**ADDENDUM - 01**

**SUBJECT:**  
RYEB Project #5633B  
Mt. Holly Township BOE  
FACILITY IMPROVEMENTS  
NJDOE SP#: 3430-050-21-1000  
& 3430-060-21-1000

**DUCT BANK DETAIL**

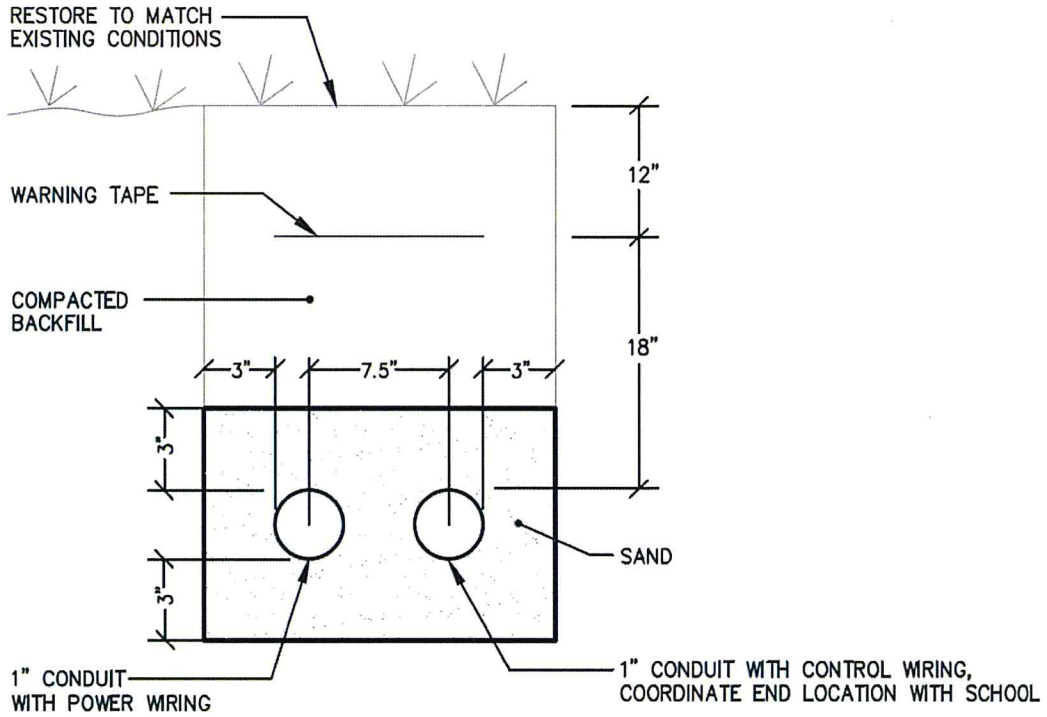
"Grind, shot blast, clean & patch as per ASTM D4259, *Standard Practice for Abrading Concrete* to expose bare concrete & provide an acceptable level floor. Prepare surface to receive specified floor finish."
- 1.09. Add: Duct Bank Detail A to Sht F-E.2 for all conduit laid in trenches.
